KEYSPAN CORP - ROCKAWAY PARK, QUEENS, NY
LOCATION = NEW YORK

**Rockaway Park Former Manufactured Gas Plant Site
Rockaway Park, Queens County, New York**

Review of Submittal

**Signed and Stamped Foundation/Anchoring System and
Revised Procedures for the Relocation of Temporary Fabric Enclosure**

TITLE:
TFS/R 36M-380 x 30M SPLIT ISO VIEW
TEMPORARY BALLAST BLOCK TIE-DOWN DETAILS

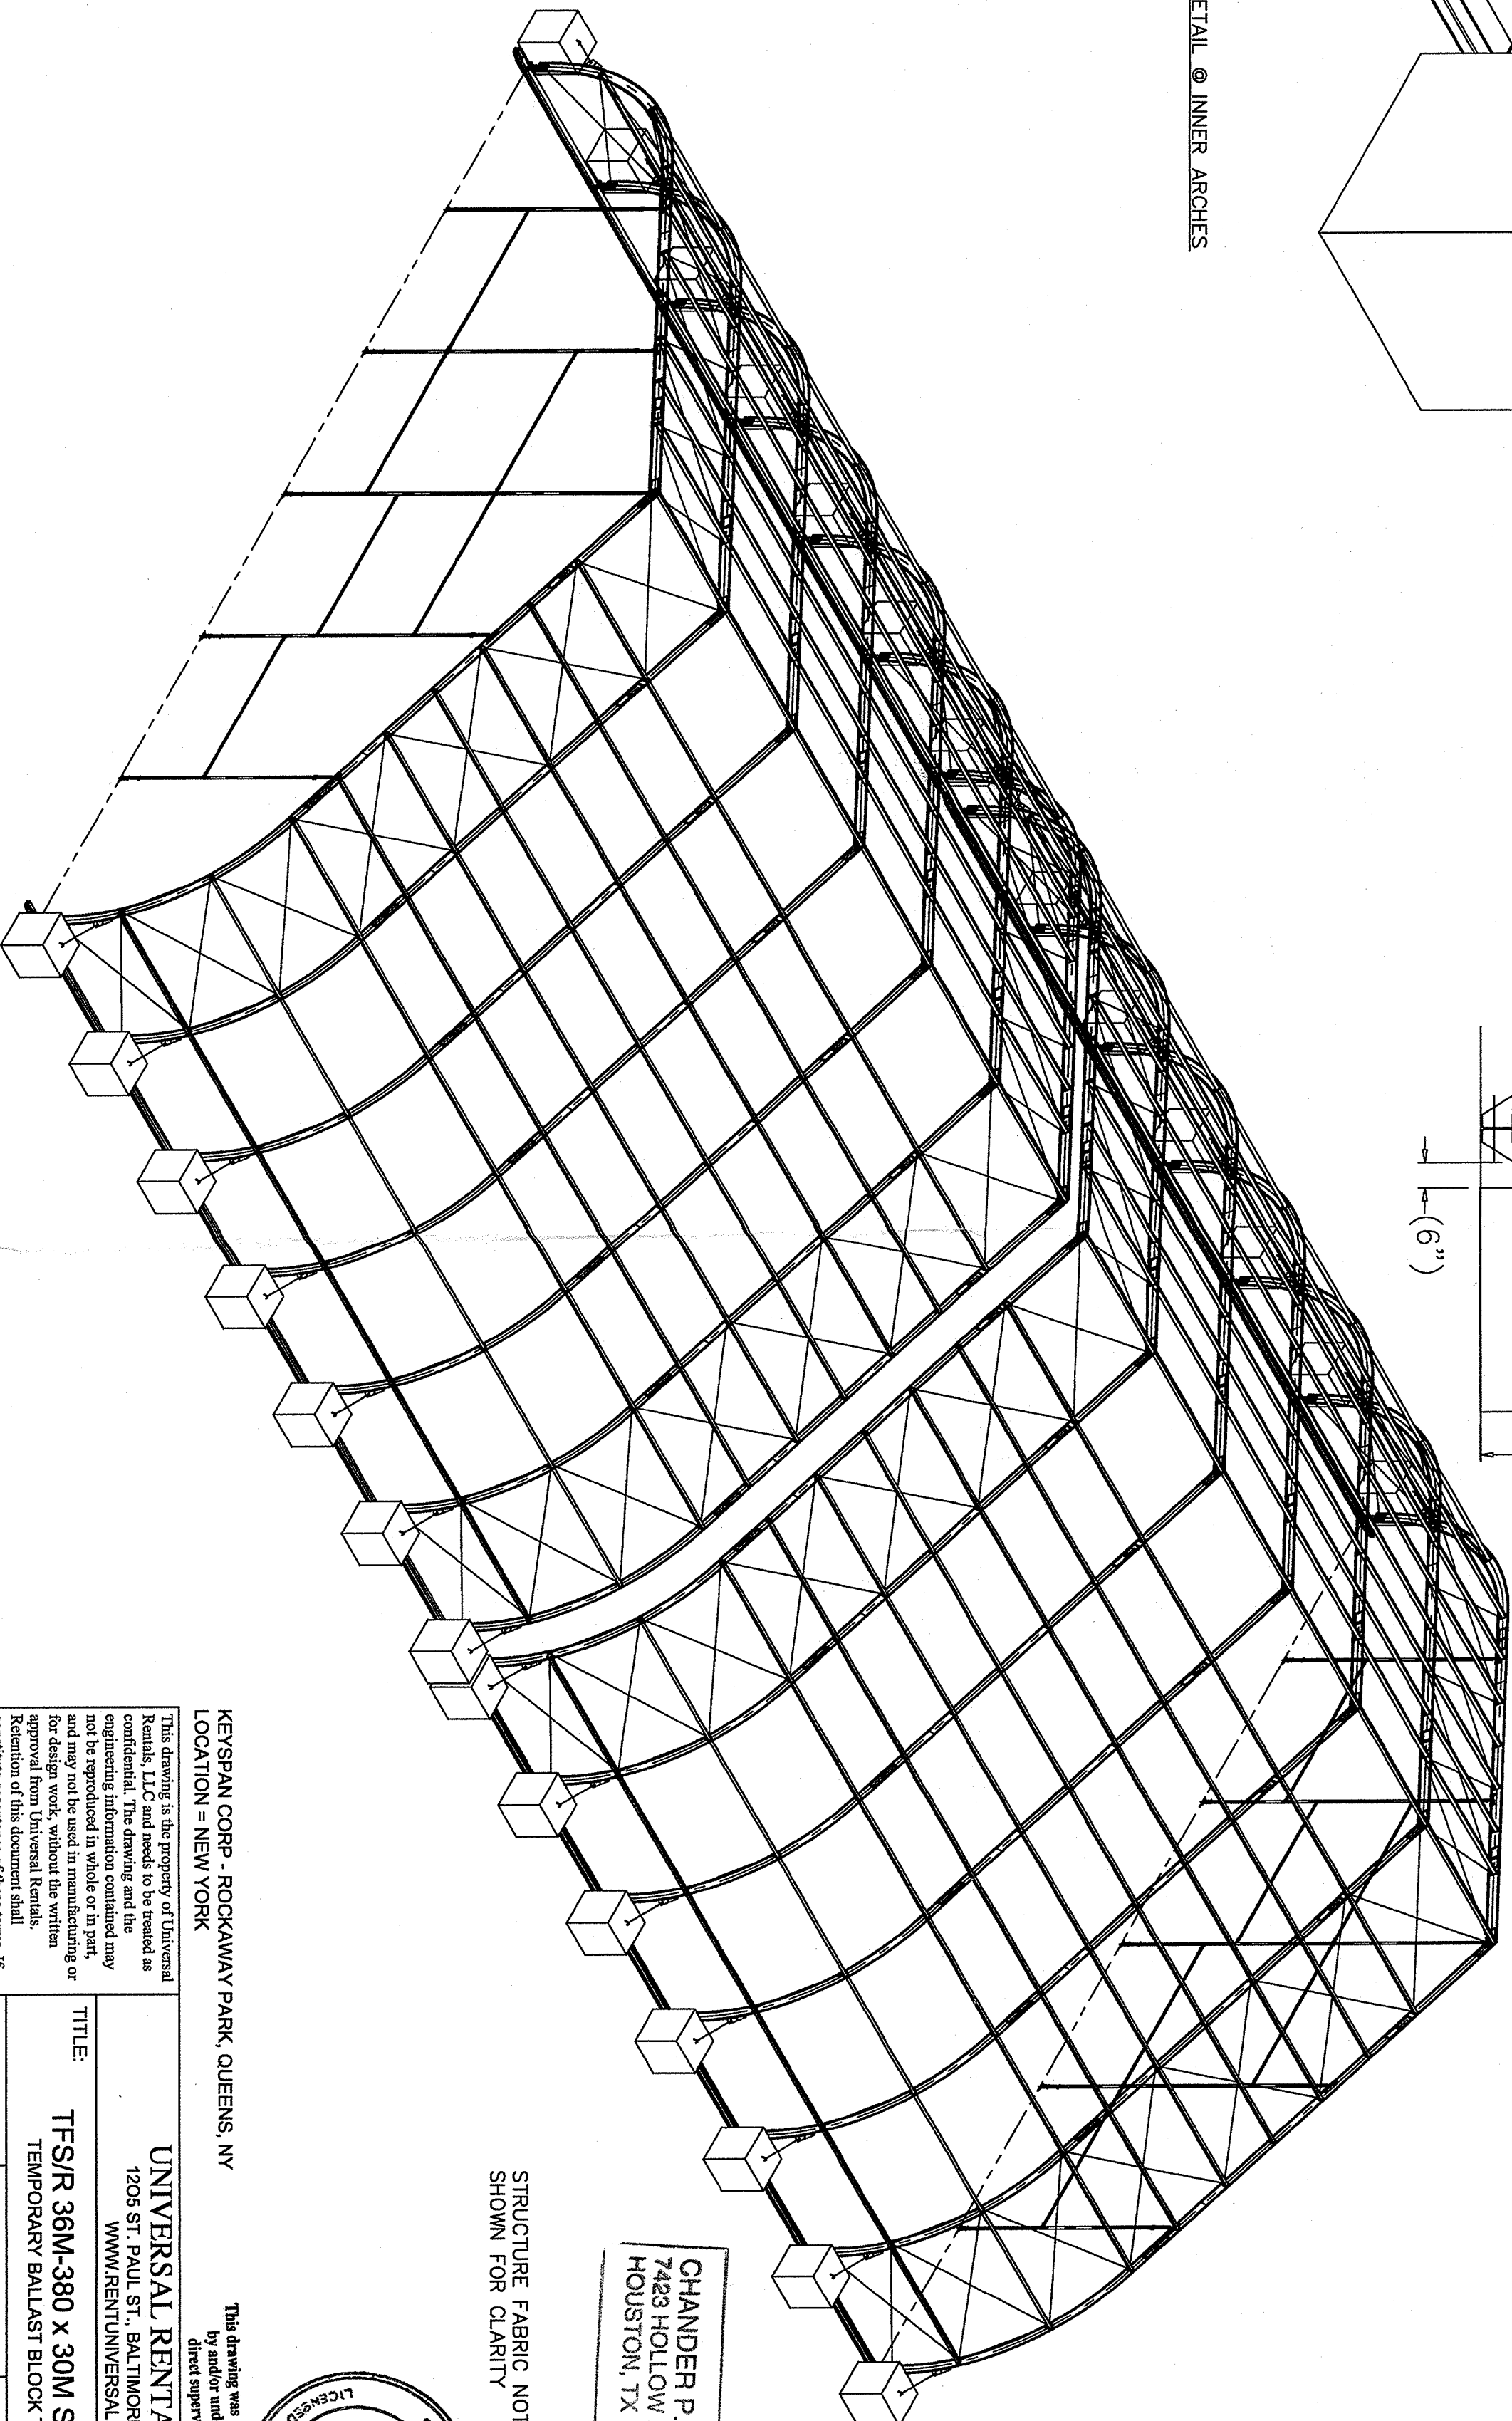
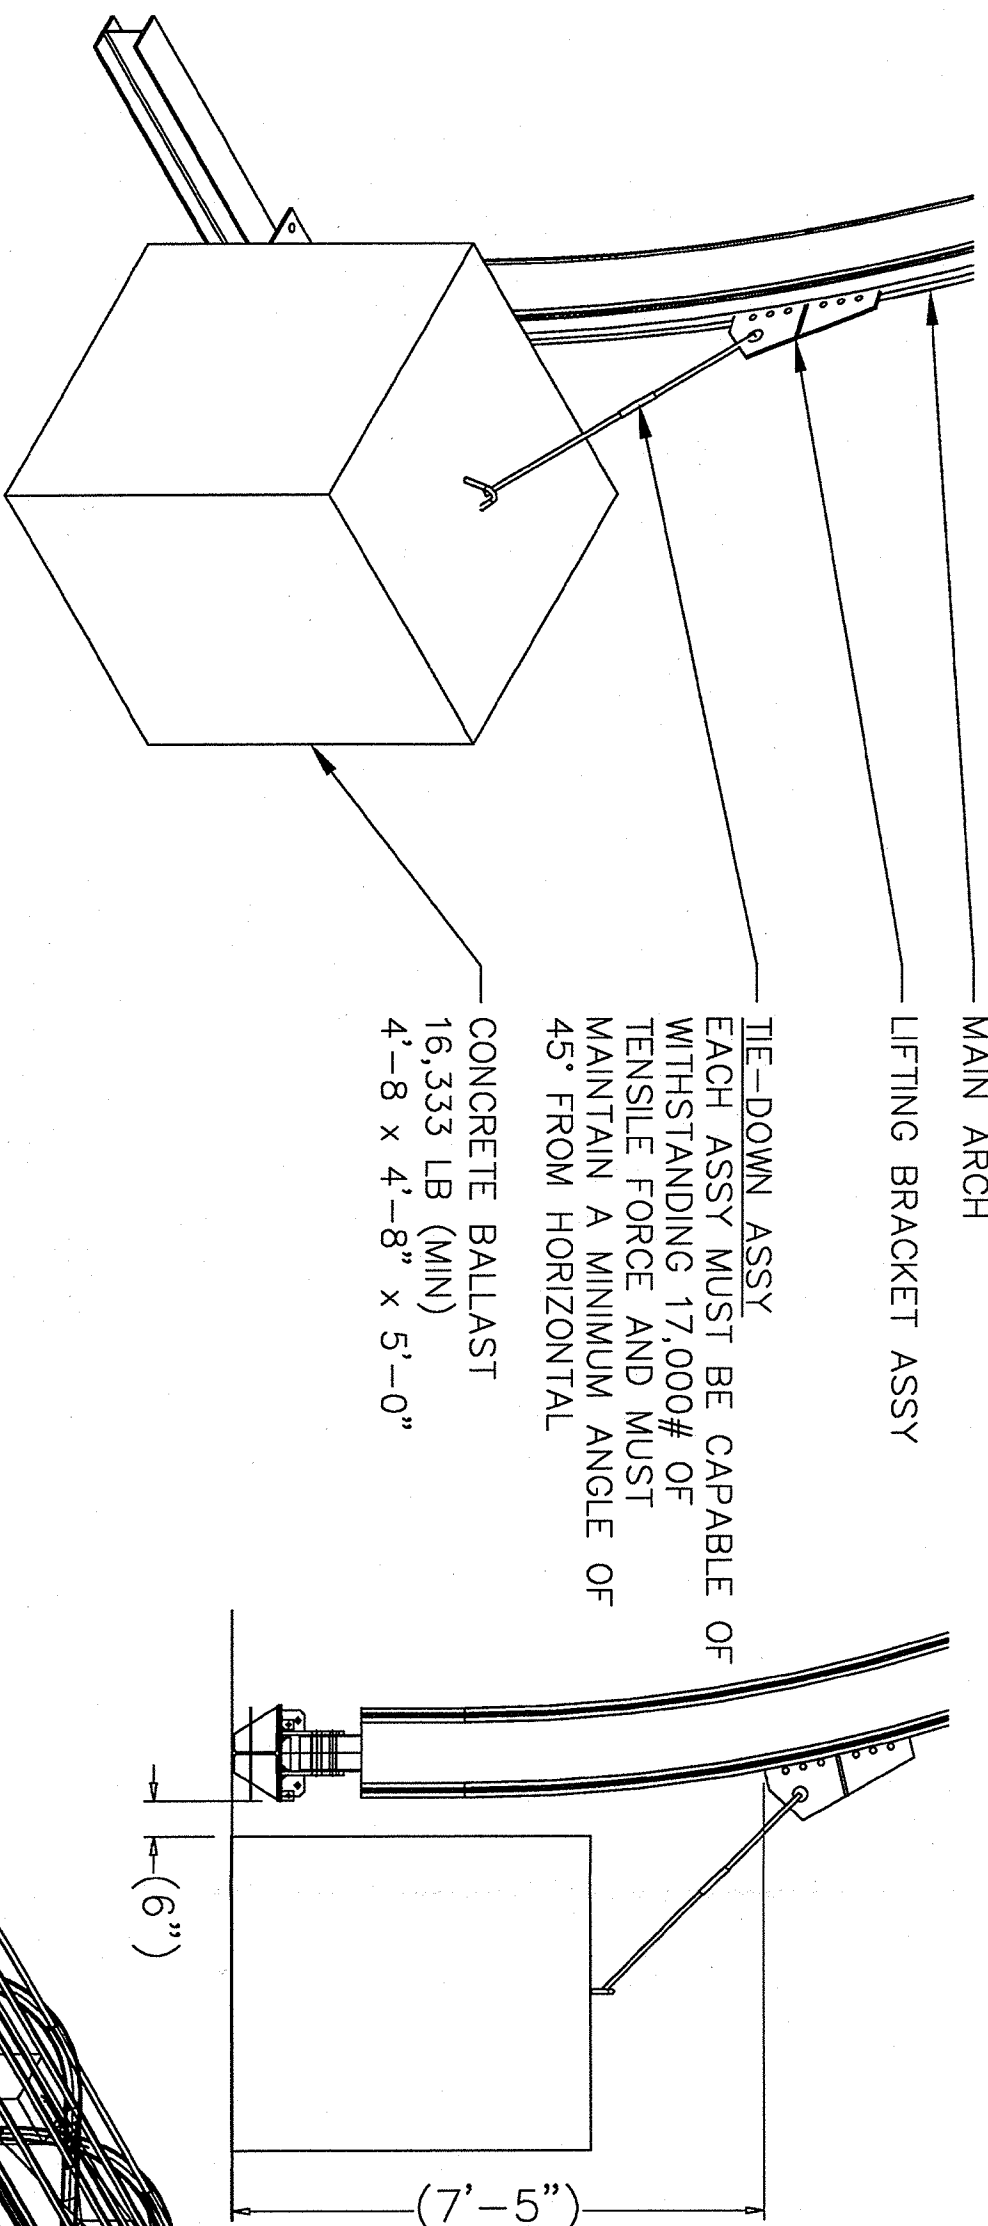
REV.	DATE	DESCRIPTION	NAME
0	09JUN08	ORIGINAL RELEASE	SF
A	18SEP08	REMOVED STAKE, MODIFIED BALLAST	SF
